PLANNING COMMISSION PACKET

MEETING AGENDA
CITY OF MOUNTAIN BROOK
PLANNING COMMISSION
OCTOBER 3, 2016

P-16-24

Additions and Renovations to St. Luke's Church (Planning Commission P-16-24)
#166009-00

CABANISS RESURVEY

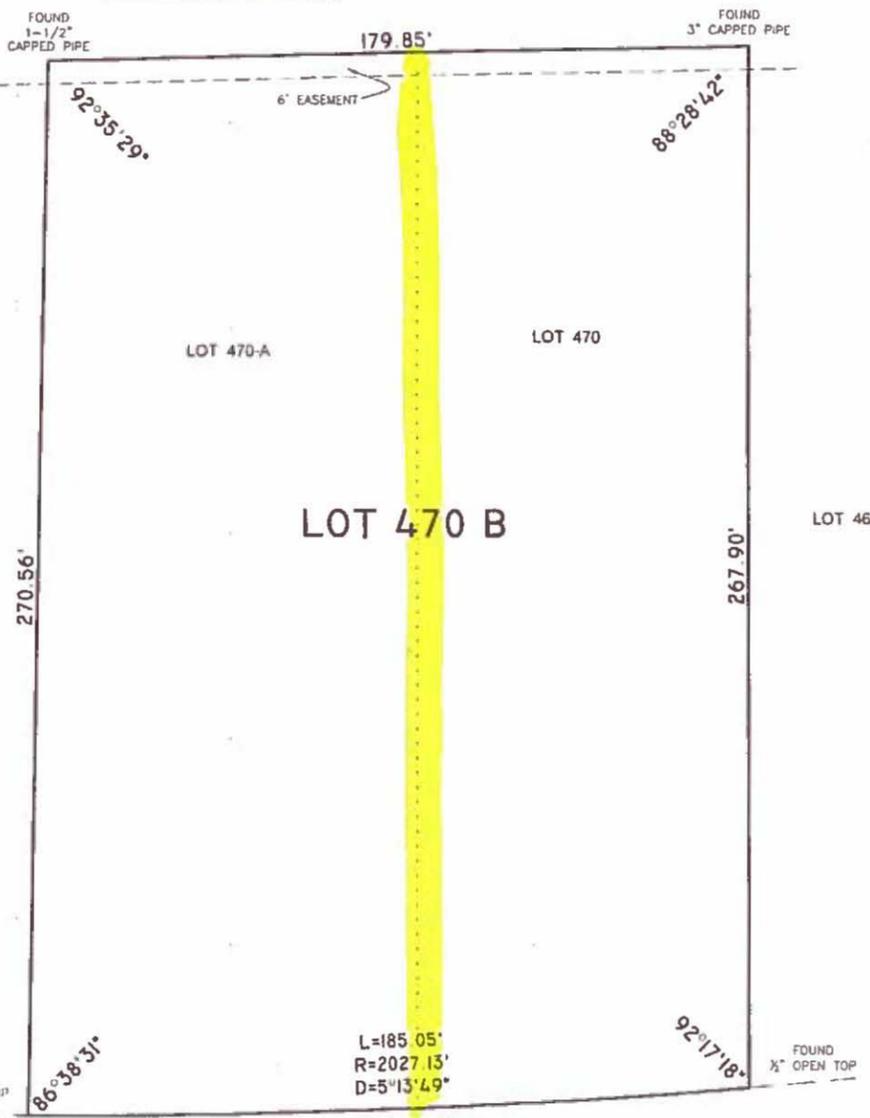
- ✓ “Clean-up” resurvey
- ☑ **May be approved as a final plat.**
- ✓ Meets the Zoning Regulations for the Res-A district.
- ✓ **Overall layout is acceptable**, with the final plat to fully comply with all applicable requirements of the Mountain Brook Subdivision Regulations.
- ✓ No floodplain present.
- ✓ No relevant history or prior cases.

DRAWING TITLE
PARKING LOT
PLANTING PLAN

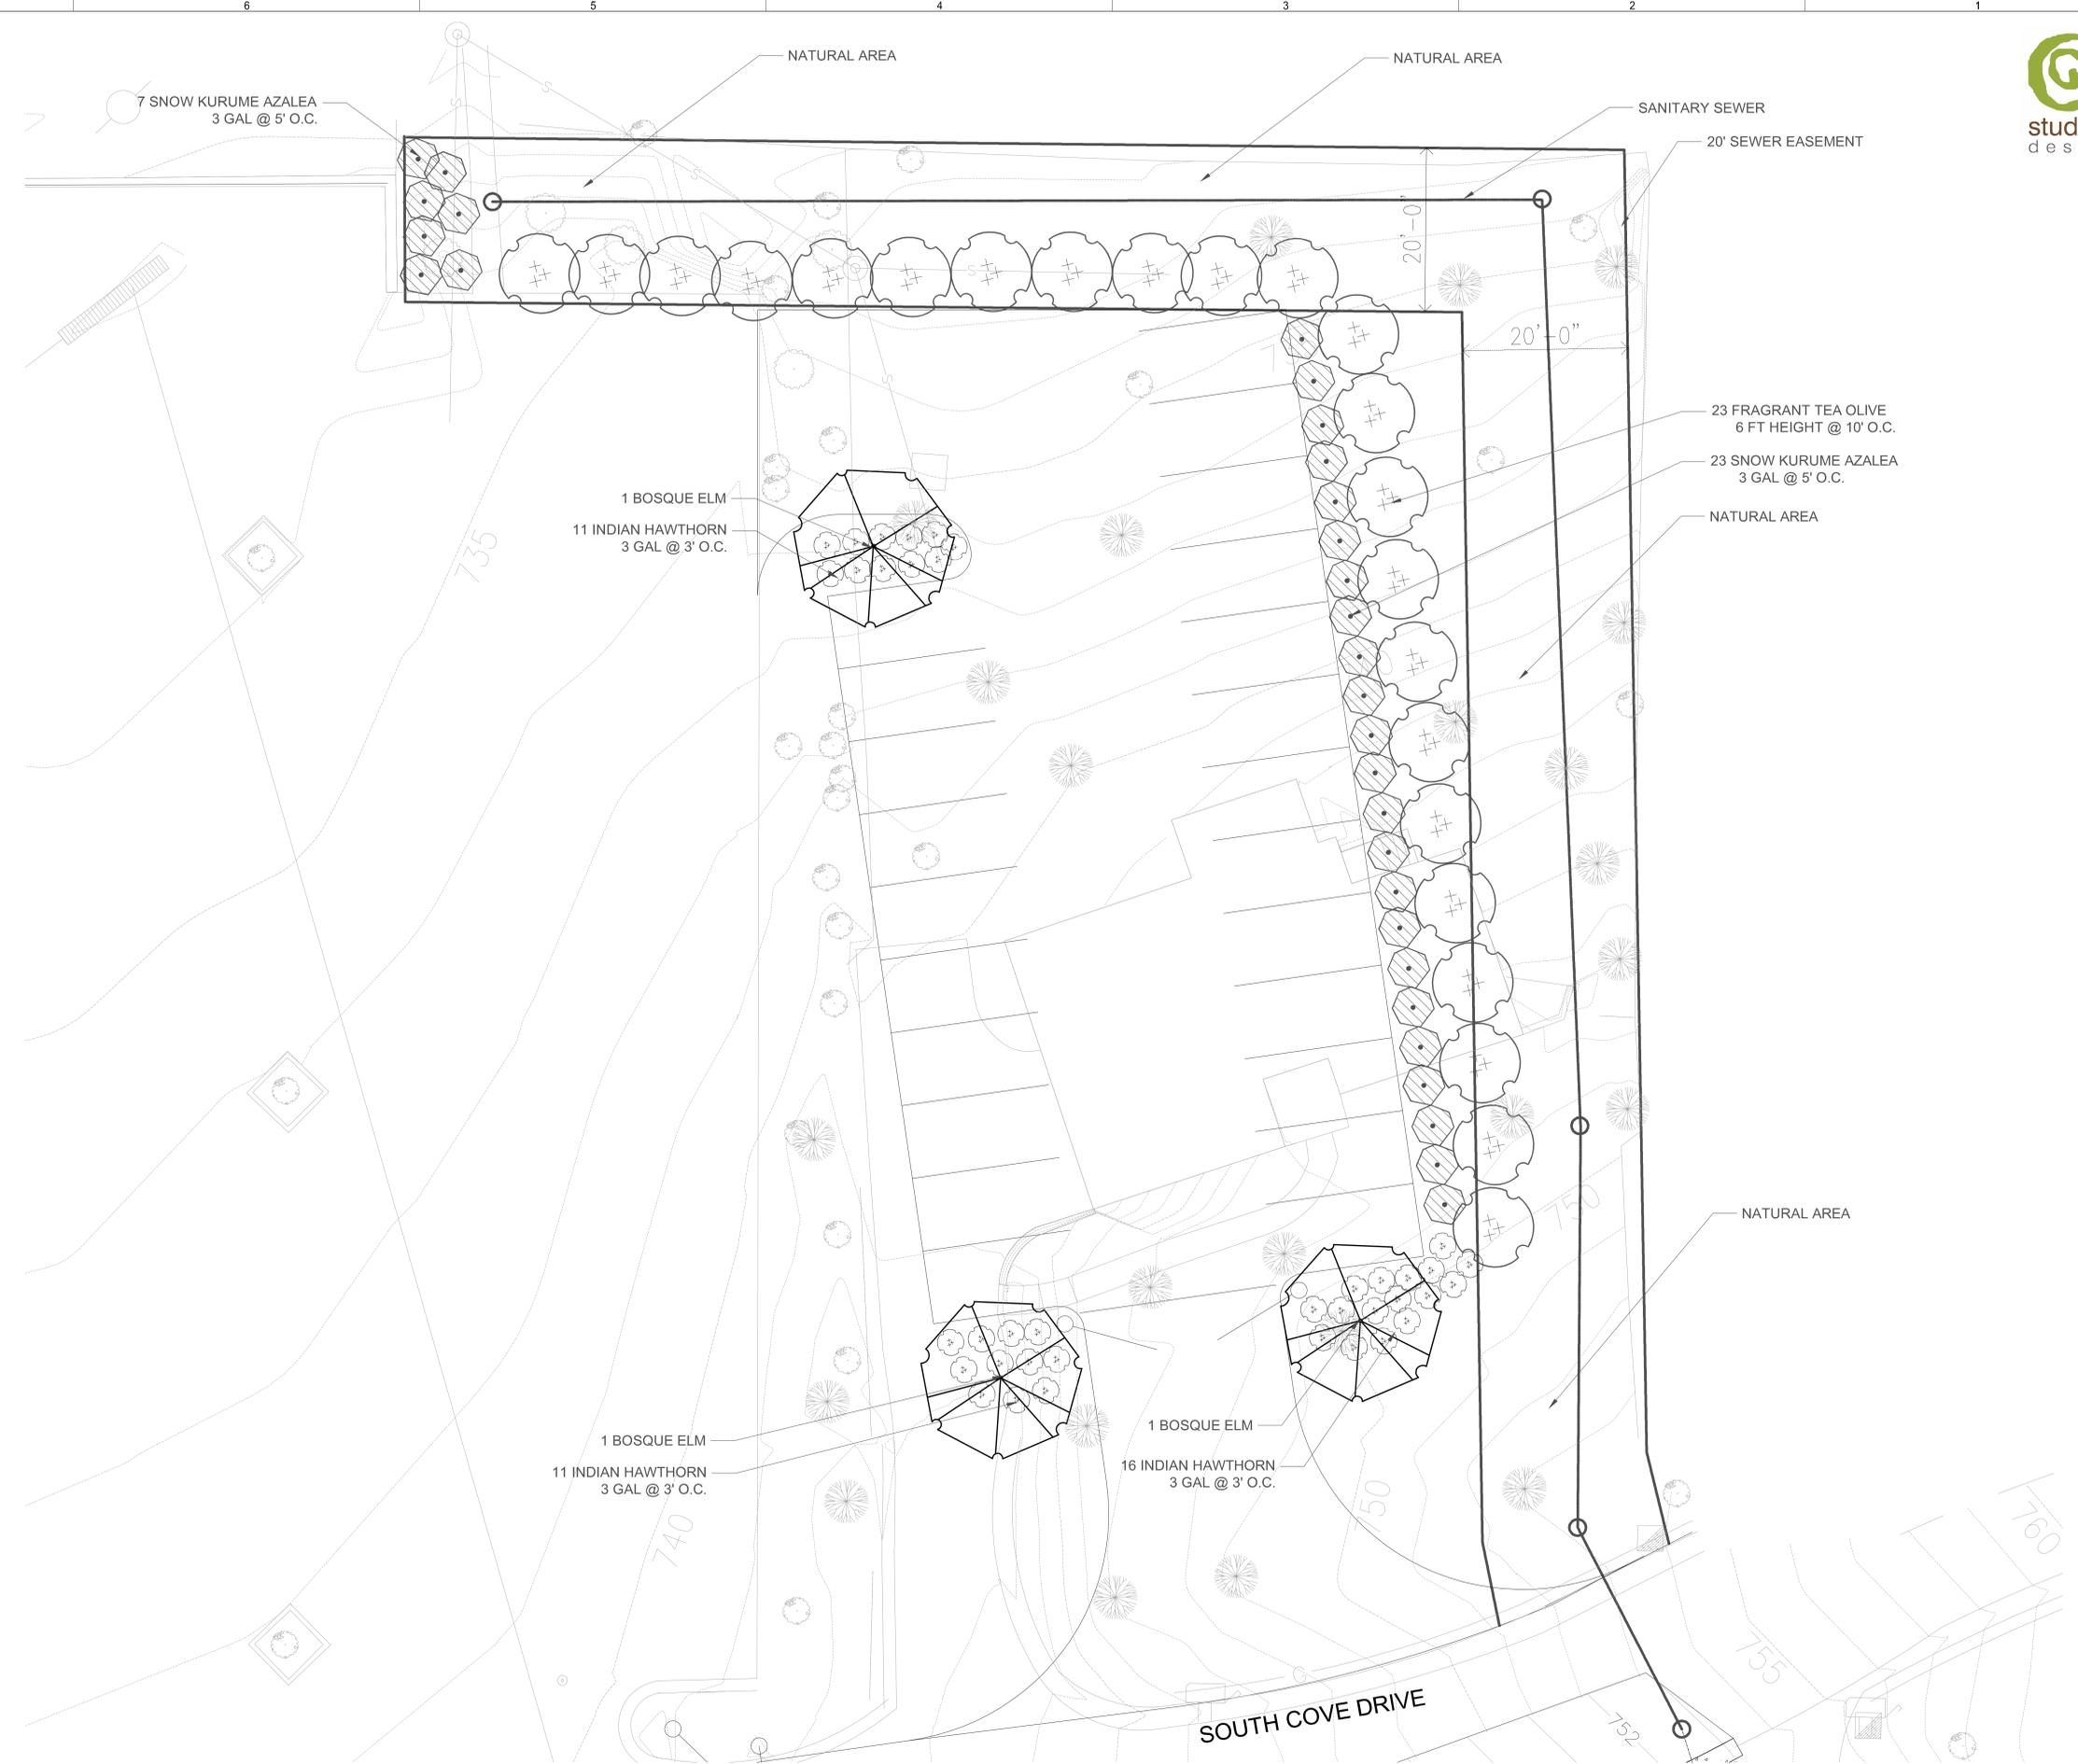
- *Schematic of the proposed landscape buffer – type of plants and location, especially in the sensitive areas along the east and north sides of the parking lot, as well as between the proposed pavilion and the south edge of the vacated South Cove Drive.*

Response – See Attachment B consisting of two landscape drawings showing proposed schematic buffer landscaping of the new parking lot and another showing the proposed schematic landscape of the area around the proposed outdoor pavilion along with a memo from Studio A our landscape architect on the plant materials.

In the first drawing the landscape for the buffer is dense evergreen shrubbery with an initial height of approximately six feet with azaleas beneath. In the second the pavilion has been moved further away from South Cove Drive by about 10 feet and has been angled slightly to better work with the existing grades, drainage, accessibility and trees.

The plant material within the buffer includes one row of Tea Olive, spaced at 10 ft o.c., as well as one row of Snow Azalea, spaced at 5 ft o.c. Three existing magnolia trees will remain in place. The remaining undisturbed landscape will be maintained as a natural area. Much of the landscape buffer falls within a Jefferson County Sewer easement. Because of this, we have been working with Richard Mixon of Jefferson County Environmental Services, sharing plans and discussing options for buffer plantings. Mr. Mixon requested that we substitute a smaller plant in lieu of our originally proposed tree species- Nellie R Stevens Holly. In response, we have proposed the Tea Olive, a small evergreen tree that typically reaches 12-14 ft in height and 10 ft in width.

Sheet Title
**BASIN MAP
PRE-DEVELOPMENT**

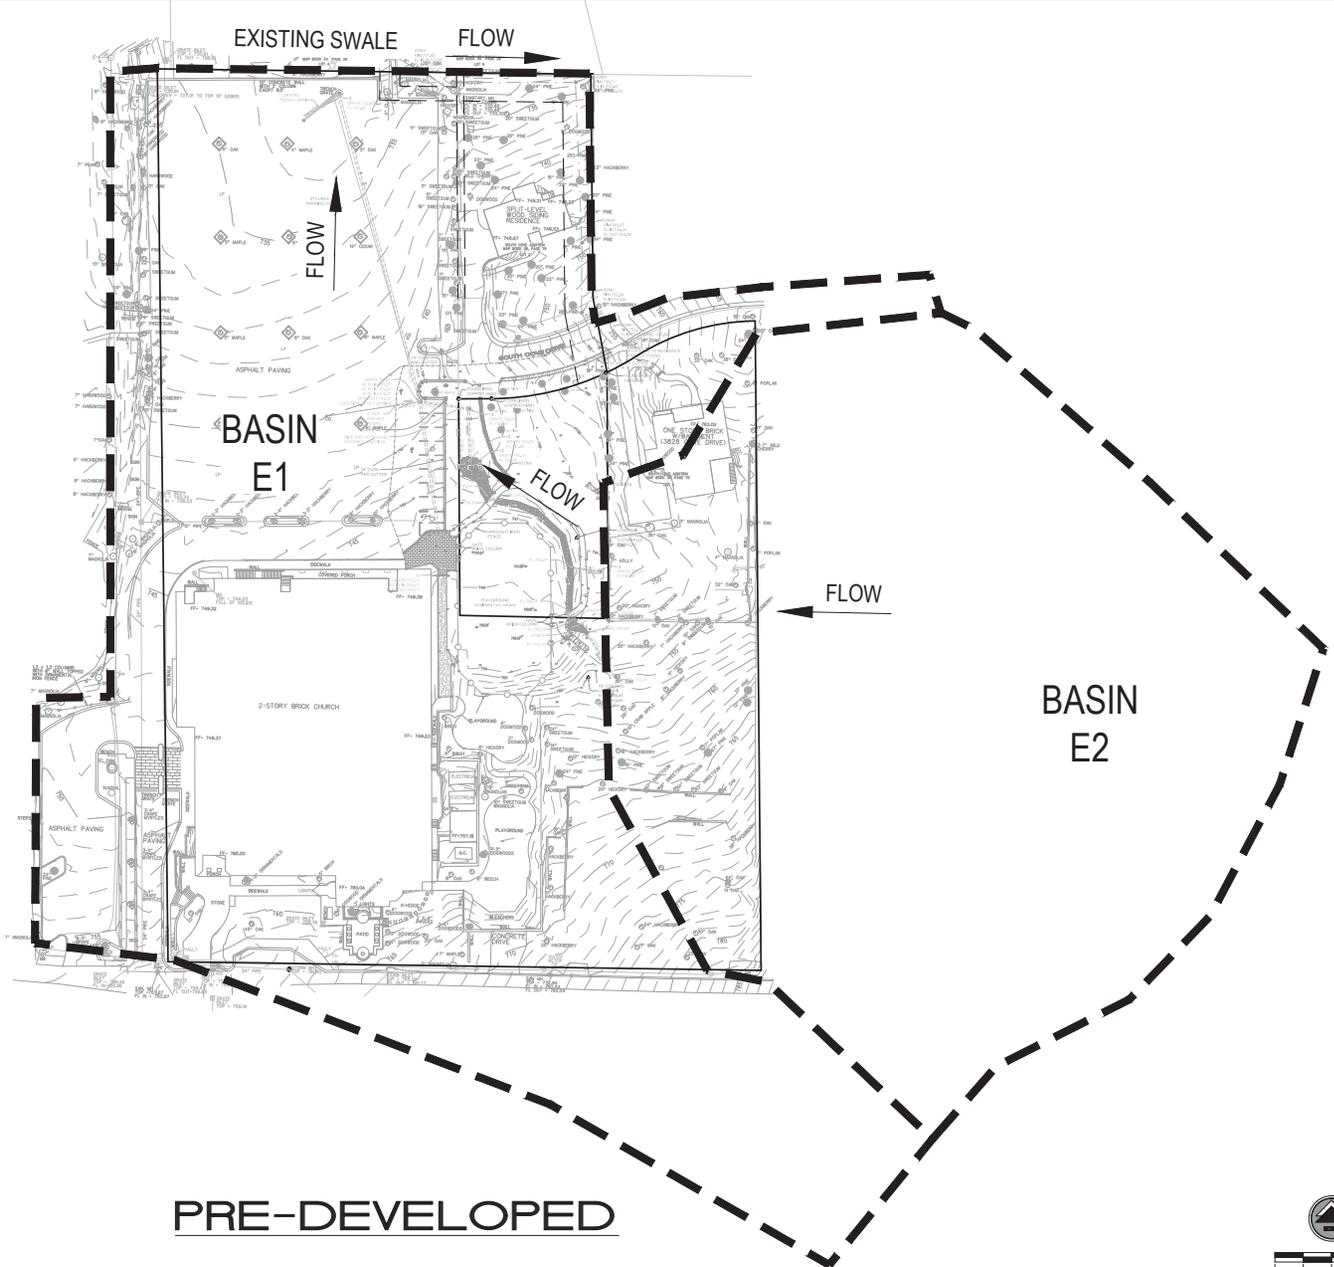
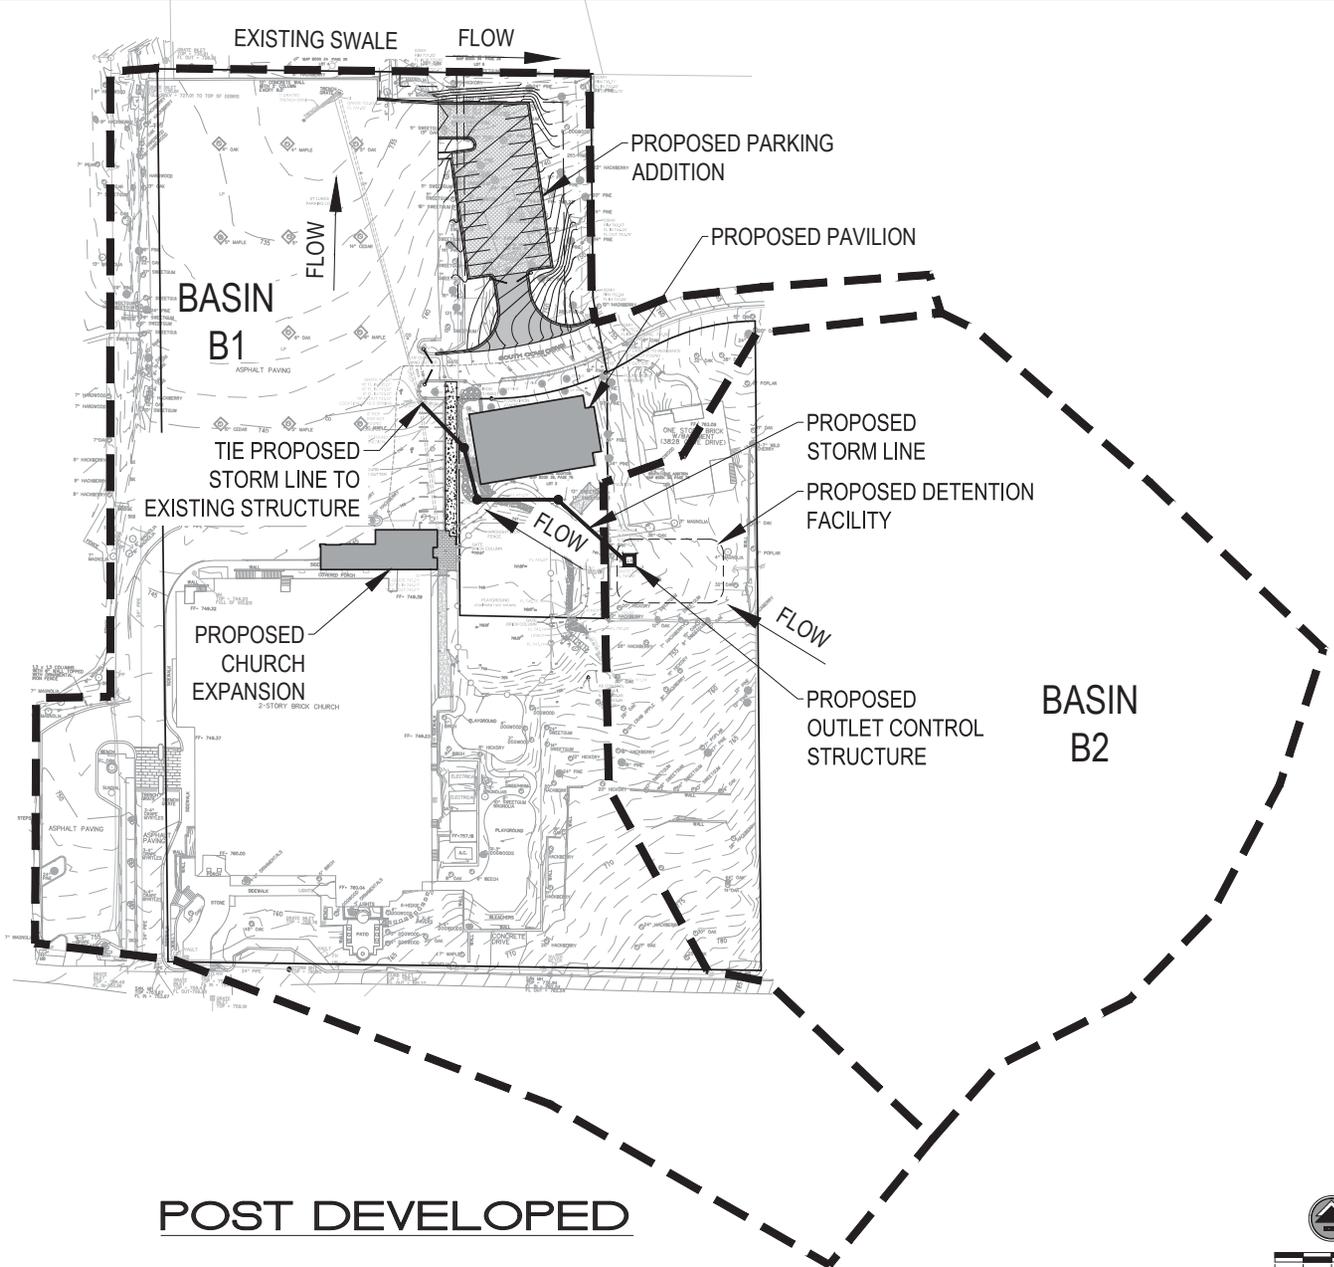
- *Analysis of drainage implications from the new parking lot.*

Response – See Attachment D consisting of a drawing and a narrative regarding the overall control of storm water on the site. The first drawing is of the new parking lot showing its location, size, preliminary grading and indicating how runoff will be handled. Essentially, storm water from this lot will be directed back on to the existing St. Luke’s parking lot and none across the property line to the north. Overall, the site will have a new detention facility located between South Cove and Montrose to insure that post development runoff is less than pre development. The detention pond will have an outlet control structure to retain storm flows.

Storm Event	Analysis @ Swale located along Northern Property Line	
	Pre-Developed Storm flows (cfs)	Post-Developed Storm flows (cfs) (Including detention)
2yr	26.1	26.0
5yr	33.4	33.4
10yr	40.2	40.2
25yr	50.7	50.1
50yr	59.7	58.8
100yr	69.4	67.8
